LHC Collimation PHASE II 3rd Design Meeting - 28/02/2008

1. Follow up of design solutions (A. Bouzoud)

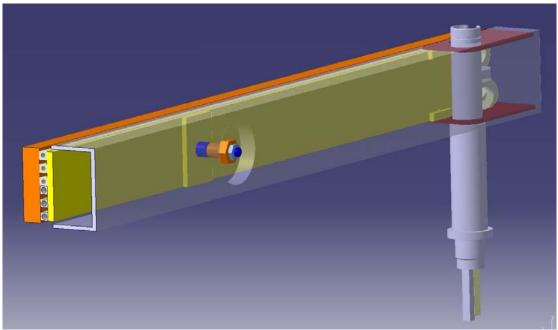
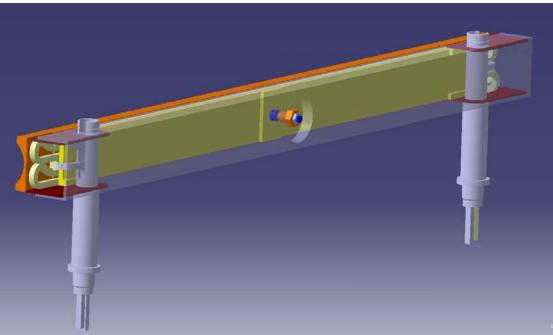
Bouzoud showed the preliminary design solution based on the idea of a jaw coupled with a rigid support beam ensuring high geometrical stability.

As shown in Figure 1 and Figure 2 cooling system is brazed on the jaw that is simply supported at the extremities and is free to expand.

The c-shaped beam is simply supported on the shafts independently from the jaw.

Jaw and support beam are connected in the middle via a control system that compensate potential deflection of the jaw.

- Design principle based on *jaw* + *rigid support beam* can work correctly only if the rigid support beam is thermally stabilized; thus, it is clear the importance of having a cooling system also on this component.
- Phase II collimation probably requires the use of high density materials for the collimation jaw in order to increase cleaning efficiency. Therefore, heat load deposited on collimators will be higher proportionally to the jaw density (as a rough estimation).
- Experience acquired with collimation phase I shows that the solution of cooling pipes brazed on the collimation jaws creates lots of problems: given that it is really difficult to obtain pipes with flat external surfaces, thus the brazing will be of low quality.

On the strength of these considerations *Bertarelli* focused on the potential advantages given by the opportunity of having welded or brazed connections inside vacuum tank. This could lead to a more efficient and powerful cooling system for the jaw as well as for rigid support beam (cooling pipes can be machined directly on a solid component). Furthermore, an efficient cooling system limits the maximum temperature with clear advantages both in terms of degassing problem as well as for the geometrical stability. *Hilleret* asked about temperature gradients on collimators; *Bertarelli* explained that it is not possible to have this information at this stage of the project, however in case of Phase I collimators, maximum temperature gradients was found on the jaw (about 40°C) while a ΔT ~2°C was detected between water and internal surface of cooling pipes.

Hilleret said that in principle it is possible to have welded and brazed connection inside vacuum: only <u>brazing under vacuum</u> and <u>electron beam welding</u> are allowed, all other types of connection are forbidden. *Hilleret* explained that detailed technical motivations are necessary in order that connections inside vacuum could be definitively accepted.

Moreover, given the potential risk of vacuum leaks introduced by the use of welded or brazed connections, great attention must be paid to safety aspects (thickness of cooling pipes, corrosion, speed of water...) and appropriate inspections must be foreseen on the connections (radiography...). A vacuum pressure of 10⁻⁸ torr is required close to the magnets (this indicative value must be verified).

Hilleret remarked that <u>double wall</u> solution is not strictly required at the moment. An issue was raised: if pipe connections will be placed near to the support shafts at jaw extremities, stresses due to thermal deformation must be carefully checked.

Figure 3: Scheme of "360° collimation jaws".

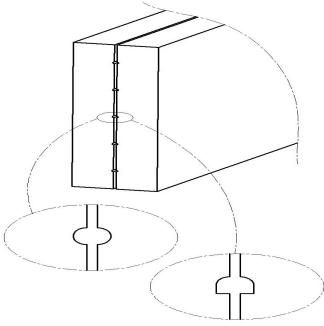
Bertarelli proposed a new solution for the design of collimation jaw. As shown in Figure 3, a series of grooves have been machined on the jaws; in this way a 360° cleaning can be performed by one collimator with potential advantage in terms of collimation efficiency. Moreover, in case of accident, jaw can be vertically moved in order to present a "fresh" undamaged groove to the beam.

This solution has some problems:

- no vertical degree of freedom
- alignment could be really difficult

However, this idea will be presented at next specification meeting and a tracking simulation will be required in order to verify if the cleaning efficiency could be increased by this solution.

Figure 6: 3D view of the jaw assembly. Brazed surfaces are highlighted.

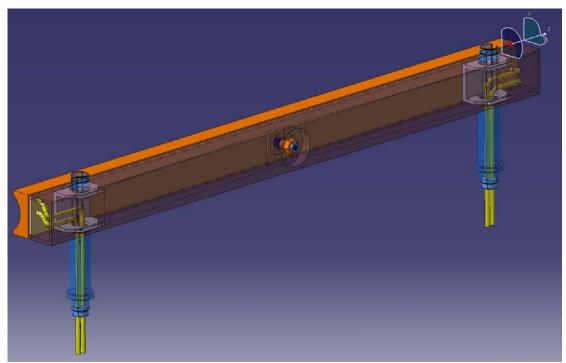
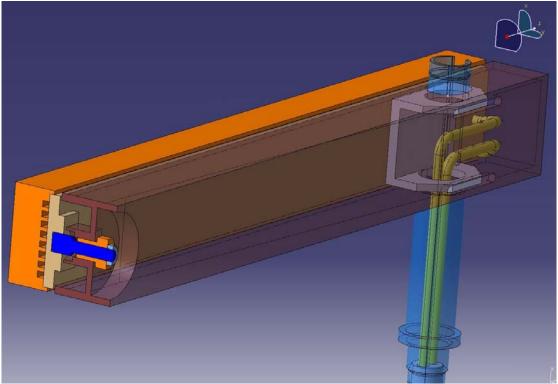
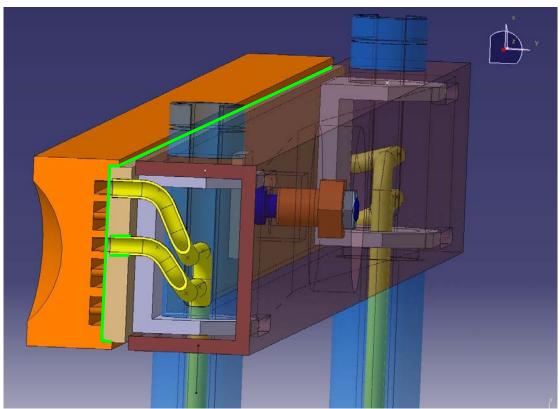
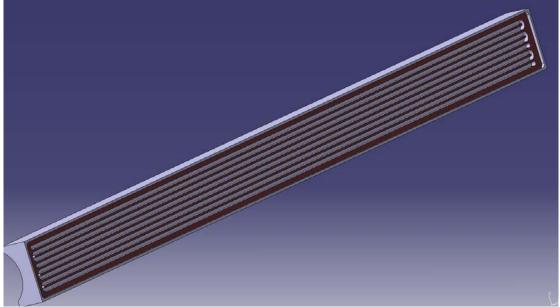
Bouzoud showed the new design solution for the cooling system based on the possibility of having welded or brazed connections inside vacuum tank. Cooling pipes have been directly machined on the jaw thus obtaining 8 pipes instead of the 6 pipes of previous solution with an increasing of the cooling surface (see Figure 5 and Figure 1). The circuit is watertight thanks to a back plate micro-brazed under vacuum on the jaw (see Figure 6). Wide brazing surface should avoid any problem of leakage. Circular pipes can be now used.

Perret proposed to change the dimension of cooling pipes: from 6×5 to $5 \times 9 \rightarrow$ from 8 pipes to 6 larger pipes in order to increase the cooling surface (5mm is the pipe dimension in the Y-direction while 9mm is the pipe dimension in the X-direction, see Figure 6). *Perret* proposed to increase also the dimension of the circular pipes in order to increase the water flow: from 6mm of internal diameter to 8mm (2mm is the thickness of the pipe).

Bertarelli remarked that distance between jaw surface and walls of cooling pipes is 26*mm*, this distance could be probably reduced having a thinner jaw (this point will be verified once energy deposition maps will be available).

Figure 8: Scheme of the proposed solution.

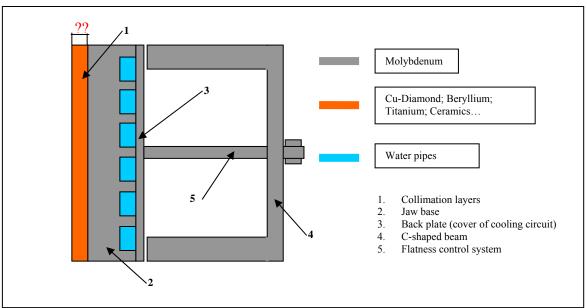
Dallocchio raised an issue: how to implement the idea of a multi-layer jaw.

The proposed solution foresees a "jaw base" on which plates made up of several materials can be brazed according to the energy deposition studies (multi-layer solution) see Figure 8.

GLIDCOP has been firstly proposed as a material for the "jaw base" but this can create problems because of the big difference between CTE of Cu-diamond and GLIDCOP.

Bertarelli proposed to use Molybdenum for the "jaw base", given its high thermal stability and its low CTE. This solution creates a problem: stiffness of the "jaw base" could become too high thus contrasting the action of the c-shaped beam.

Perret proposed a solution for this problem: cooling circuit on the "jaw base" can be divided into two separated circuits closed by two back-plates thus leaving a free region in the middle of the "jaw base". This central region can be opportunely weakened in order to reduce the "jaw base" stiffness. The aim is to obtain a jaw with low stiffness coupled with a very rigid c-shaped beam that gives geometrical stability to the system. Figure 8 shows a scheme of the proposed solution.
